ADDITIONAL DNAPL RECOVERY WELL INSTALLATION AND TESTING WORK PLAN

**DETREX RD/RA SOURCE CONTROL AREA
DETREX FACILITY
ASHTABULA, OH
DOCKET NO. V-W-98-C-450**

Subject: Submittal of Final Additional DNAPL Recovery Well Installation and
Testing Work Plan
Detrex Source Control Area – Fields Brook Superfund Site
Detrex Corporation, Ashtabula, Ohio
Docket No. V-W-98-C-450

**TECHNICAL REVIEW COMMENTS ON
"ADDITIONAL DNAPL RECOVERY WELL INSTALLATION
AND TESTING WORK PLAN"
URS Corporation, February 2012**

DRAWN BY: AMH	CHECKED BY: MLS	PROJECT No: 13814613	DATE: 8/21/12	FIGURE No: 2-1
------------------	--------------------	-------------------------	------------------	-------------------

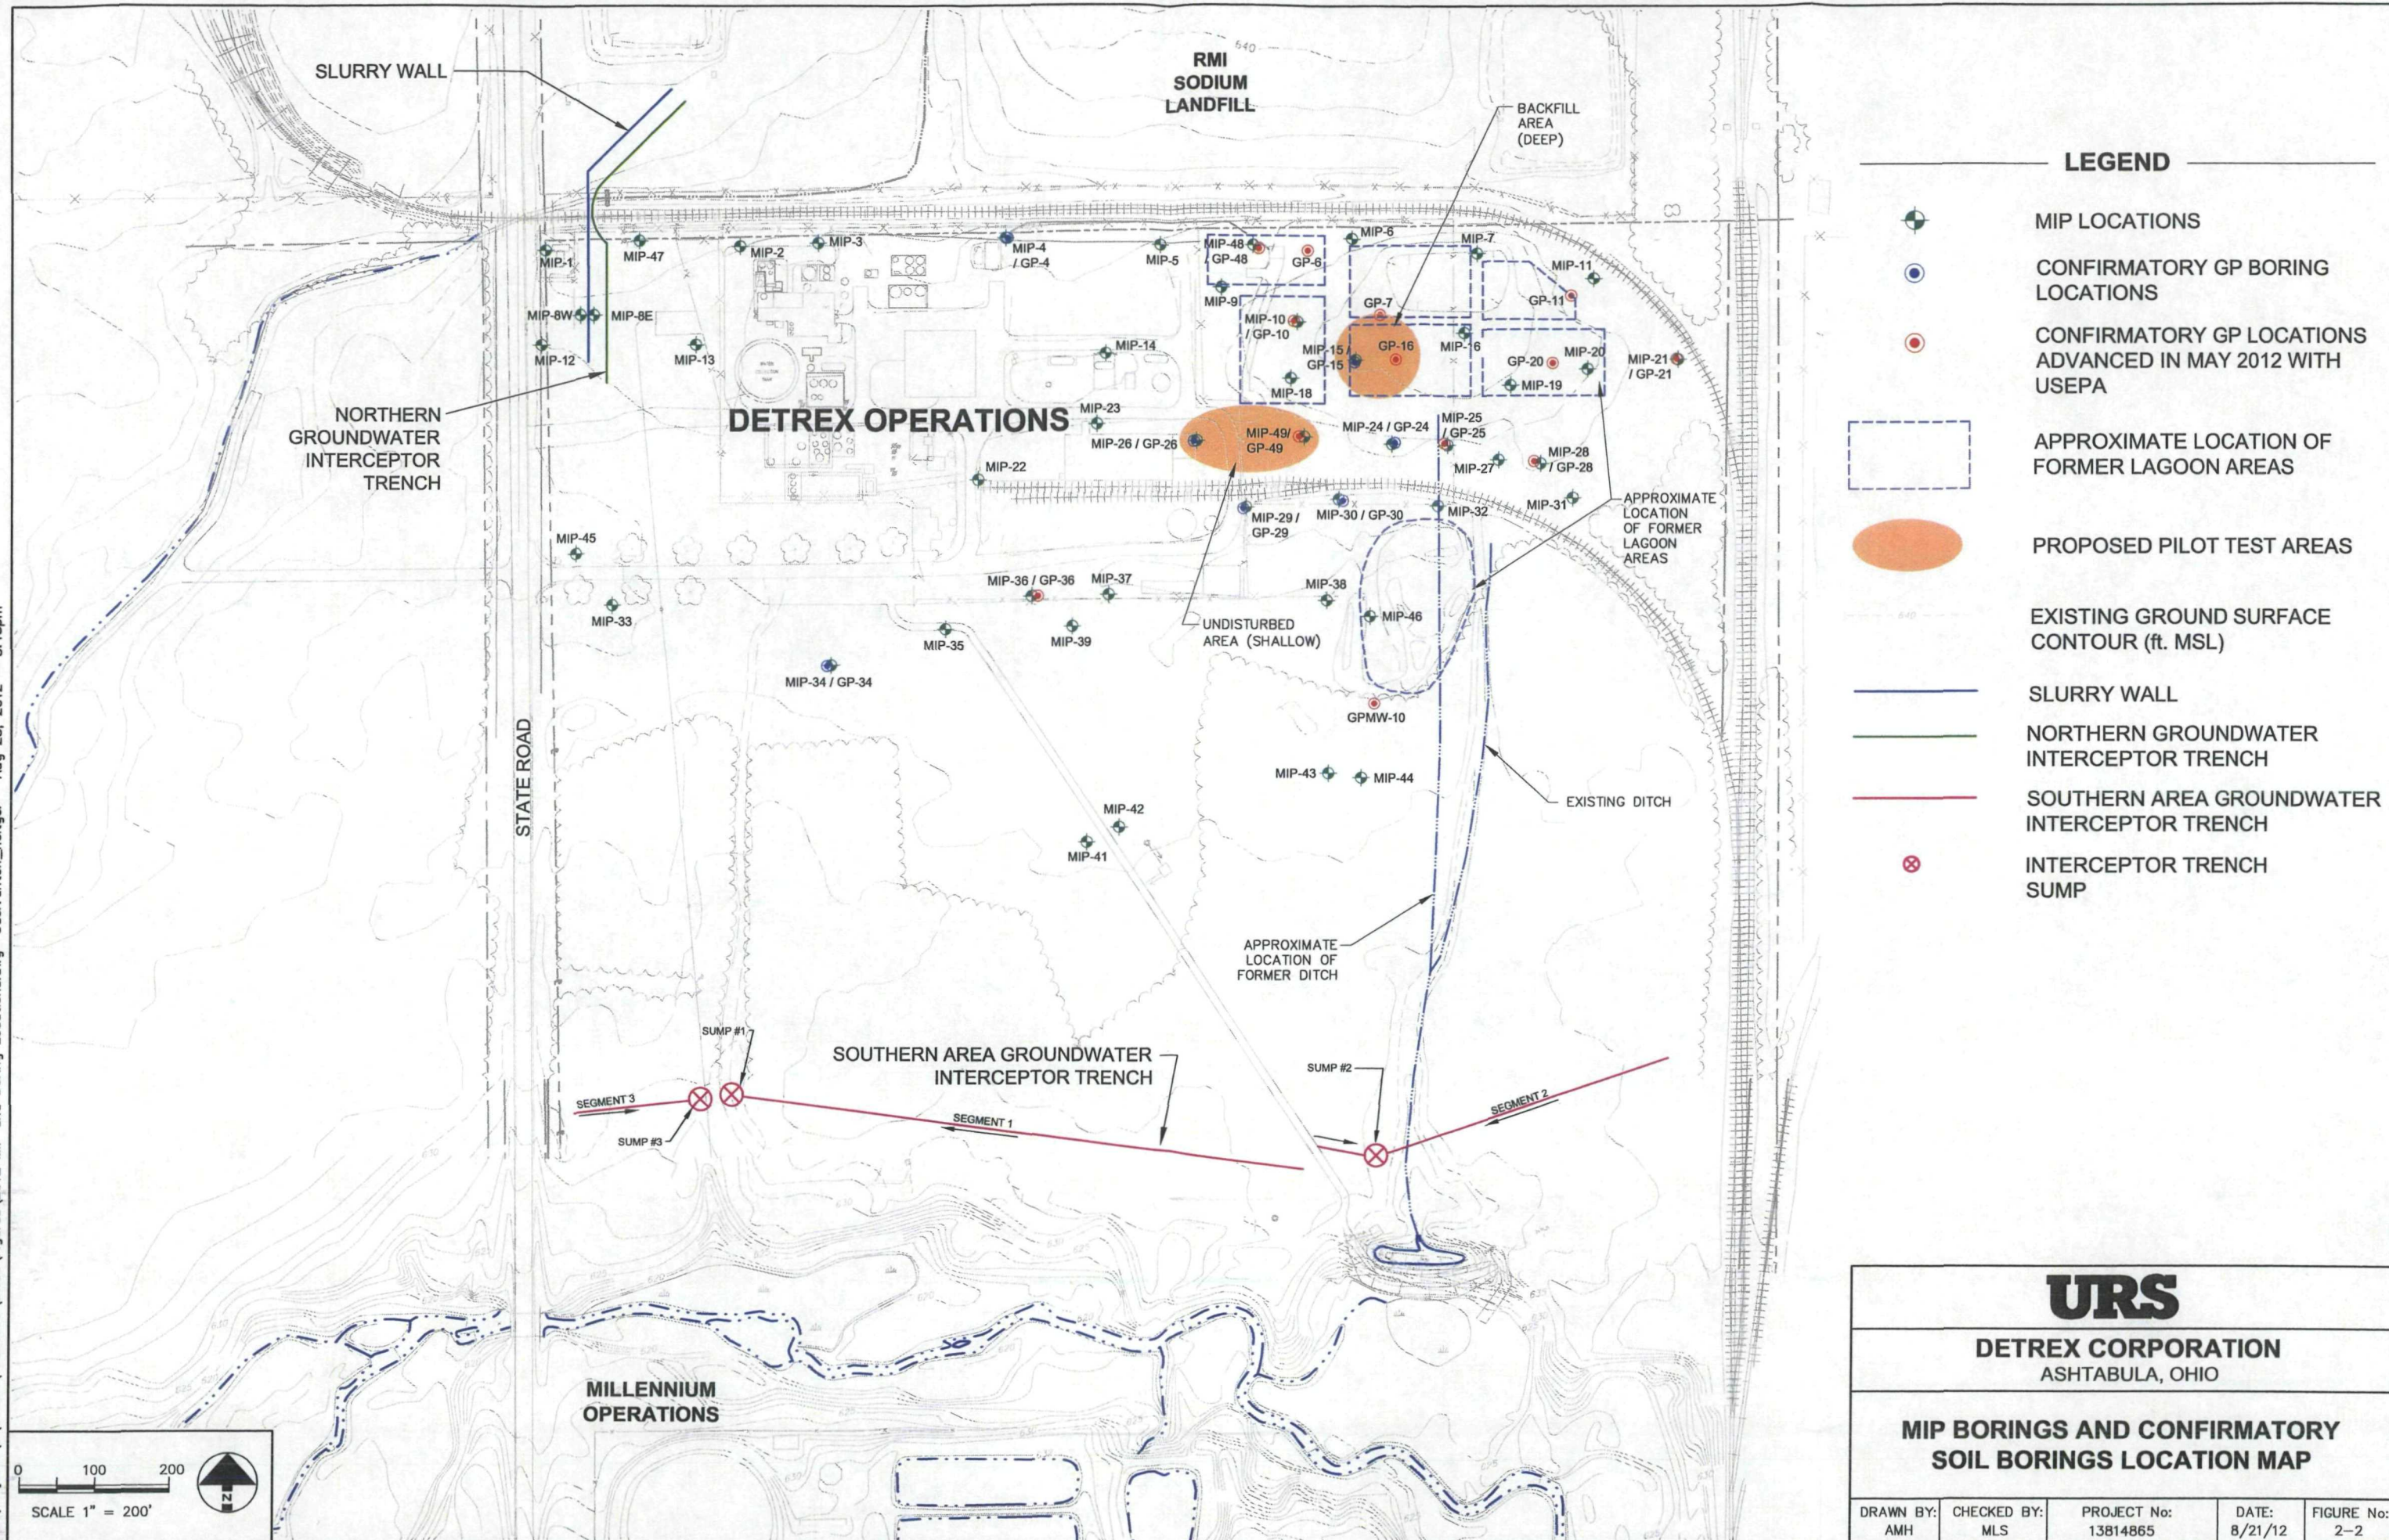
3. Section 2.1.1, Page 2-1: The text states that Figure 2-1 depicts the location of the existing DNAPL recovery wells. Please revise Figure 2-1 or add another figure to depict the location of the existing wells. The text also states that the DNAPL recovery system has recovered an estimated 16,000 gallons of DNAPL. Revise this to 18,000 gallons.

Specific Comment #3 - Section 2.1.1, Page 2-1: The text states that Figure 2-1 depicts the location of the existing DNAPL recovery wells. Please revise Figure 2-1 or add another figure to depict the location of the existing wells. The text also states that the DNAPL recovery system has recovered an estimated 16,000 gallons of DNAPL. Revise this to 18,000 gallons.

Detrex agrees, and the text will be corrected and submitted in the Final Work Plan document. Figure 2-1 has been revised to show the locations of existing monitoring wells and DNAPL recovery wells.

DRAWN BY: AMH	CHECKED BY: MLS	PROJECT No: 13814865	DATE: 8/20/12	FIGURE No: 2-3
------------------	--------------------	-------------------------	------------------	-------------------

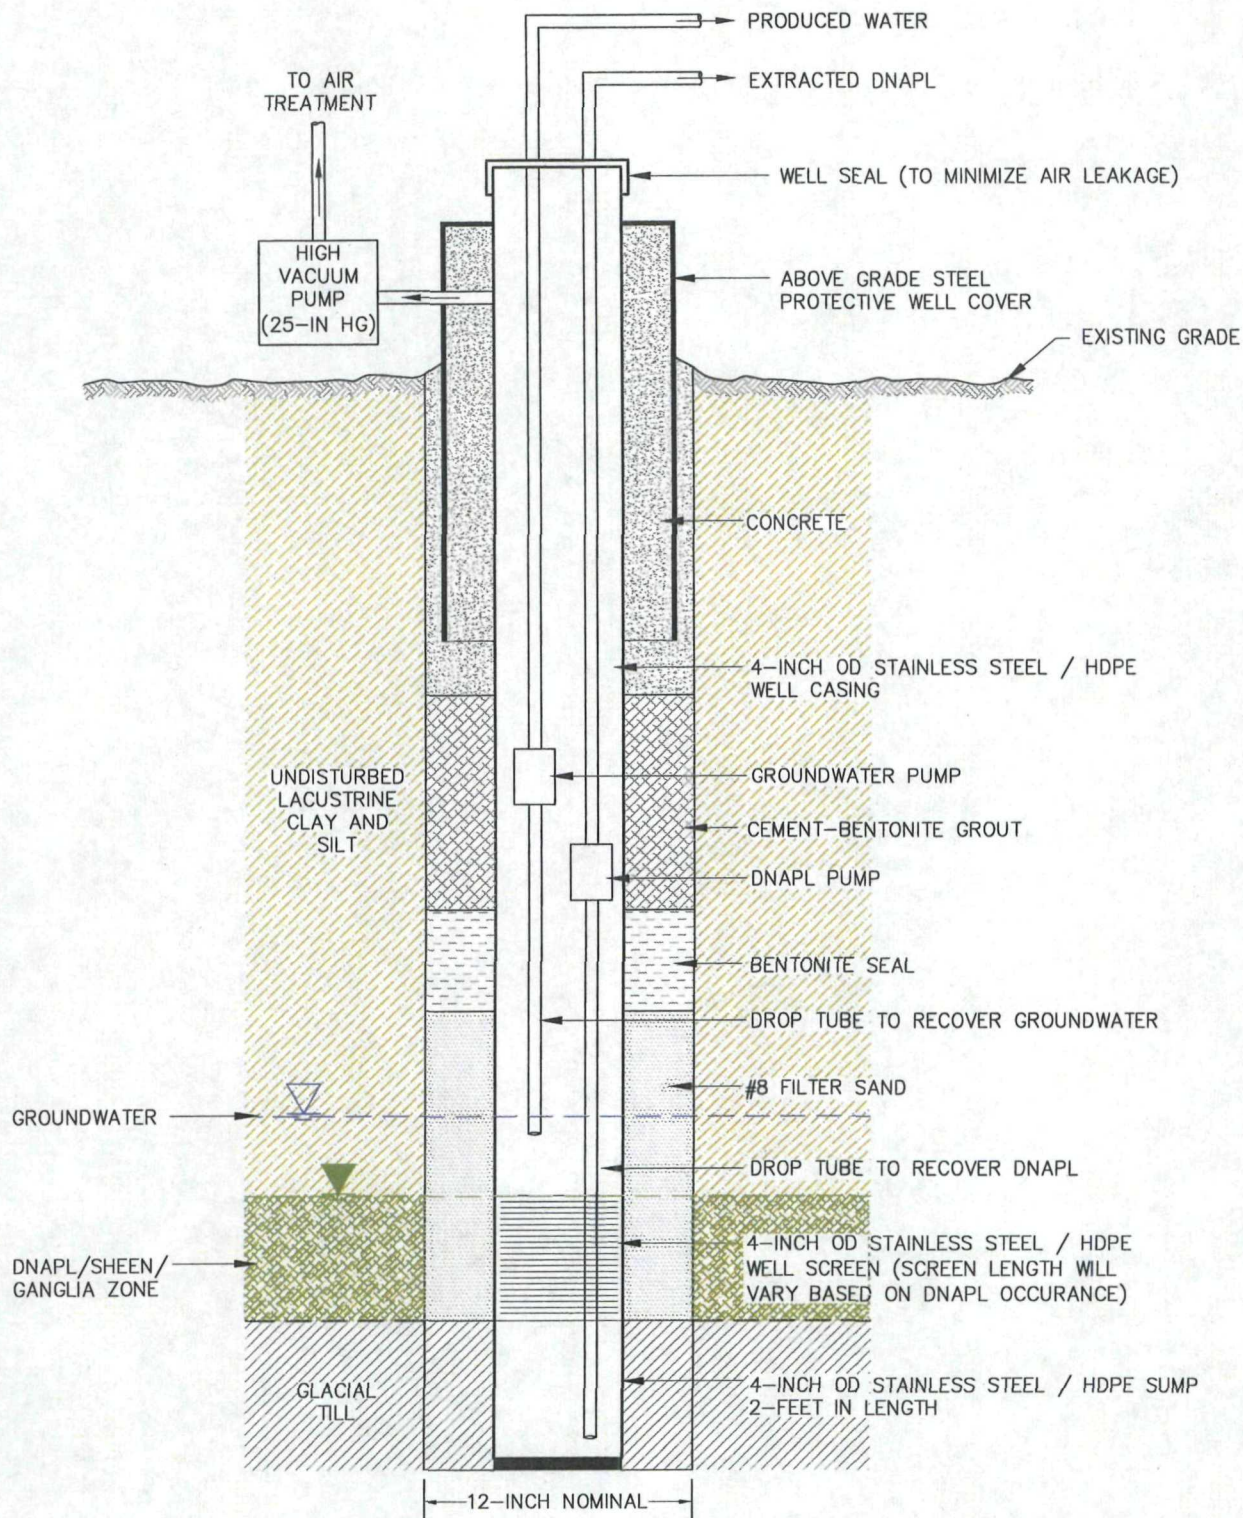
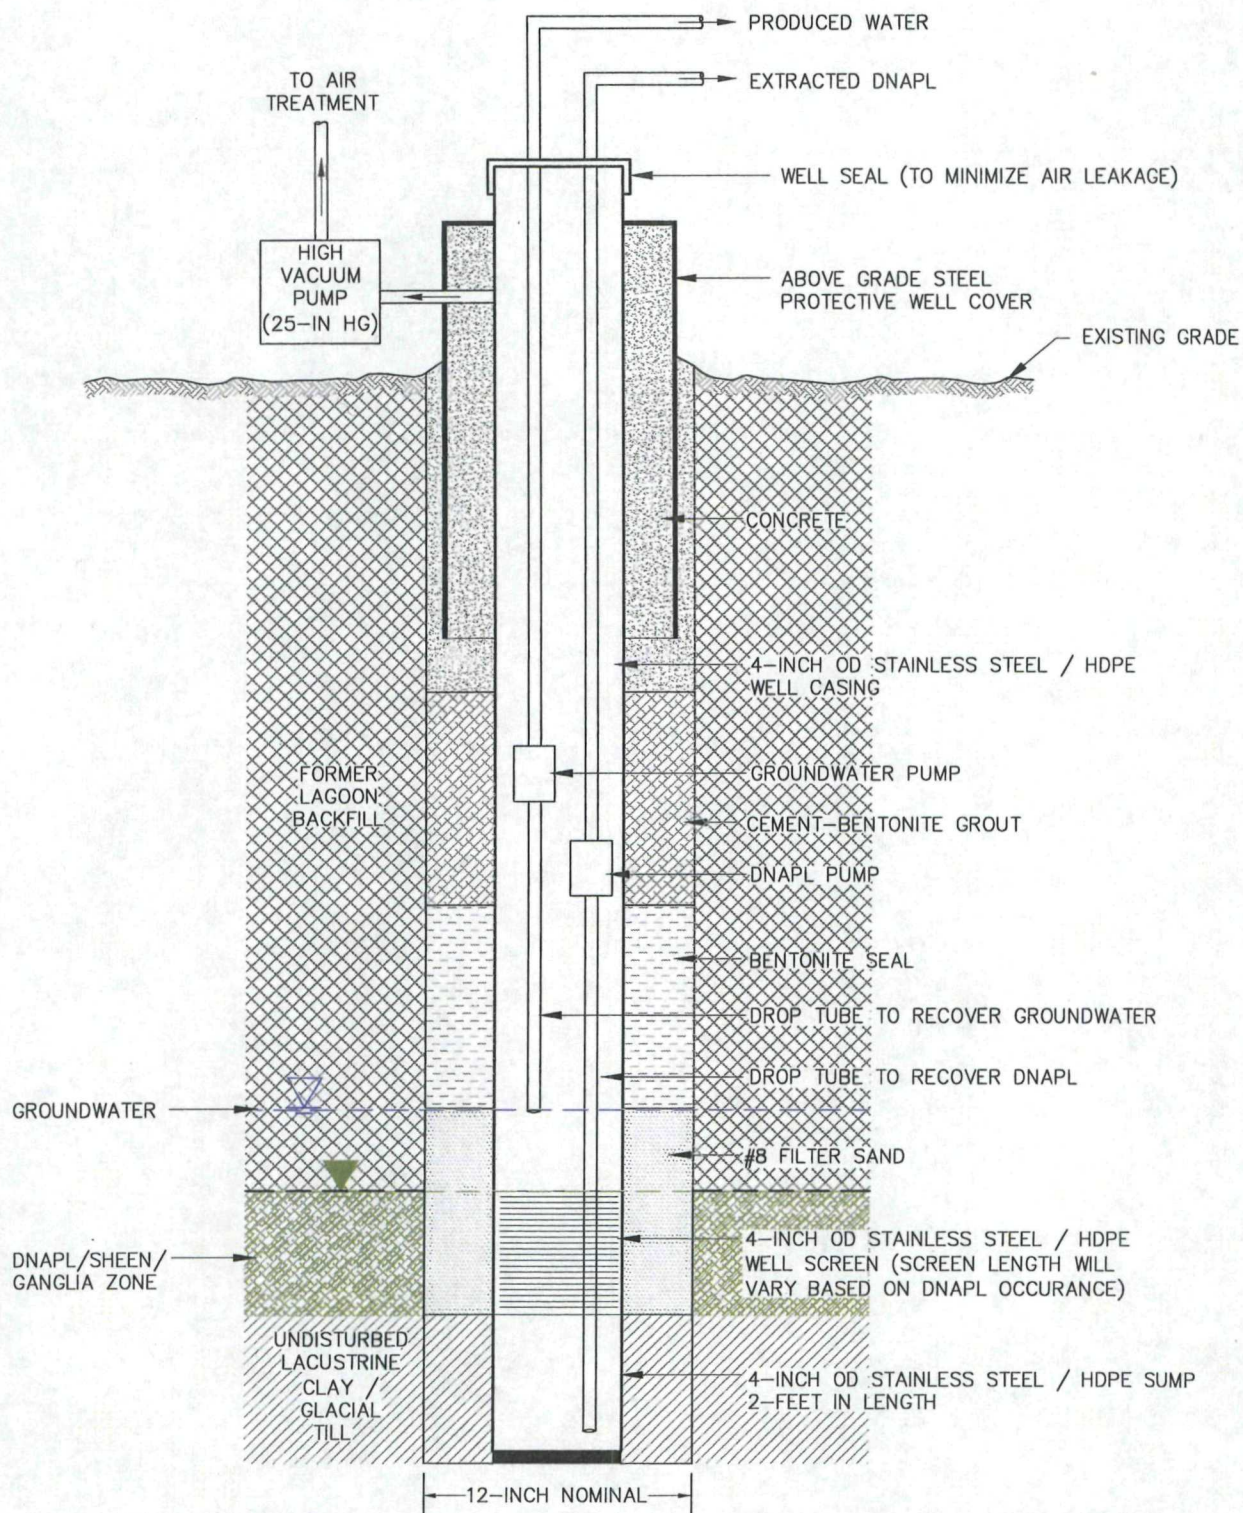
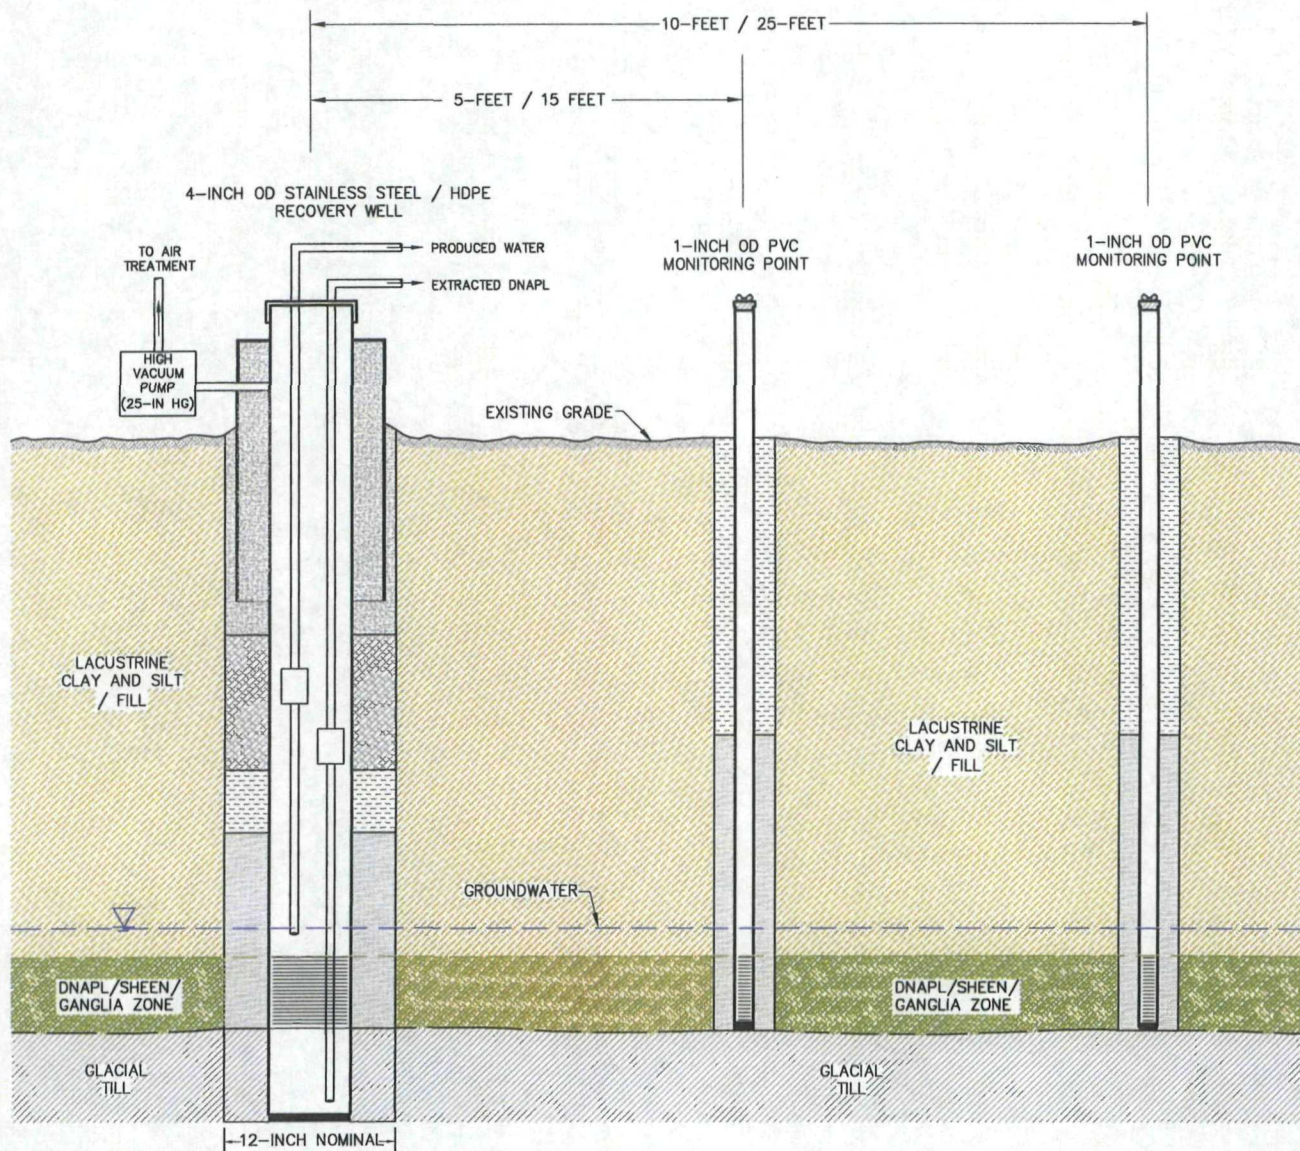
11. Section 2.3.5, Page 2-8; and Figures 2-4 and 2-5: The text states that "new DNAPL recovery wells will be installed in 12-inch diameter boreholes"; however, Figures 2-4 and 2-5 show the boreholes as having a 10-inch-diameter. The text and figures should be revised as needed to resolve this discrepancy.

Specific Comment #11 - Section 2.3.5, Page 2-8; and Figures 2-4 and 2-5: The text states that "new DNAPL recovery wells will be installed in 12-inch diameter boreholes"; however, Figures 2-4 and 2-5 show the boreholes as having a 10-inch-diameter. The text and figures should be revised as needed to resolve this discrepancy.

Detrex agrees. Figures 2-3, 2-4, and 2-5 have been revised to reference the use of 12 inch boreholes for DNAPL recovery wells.
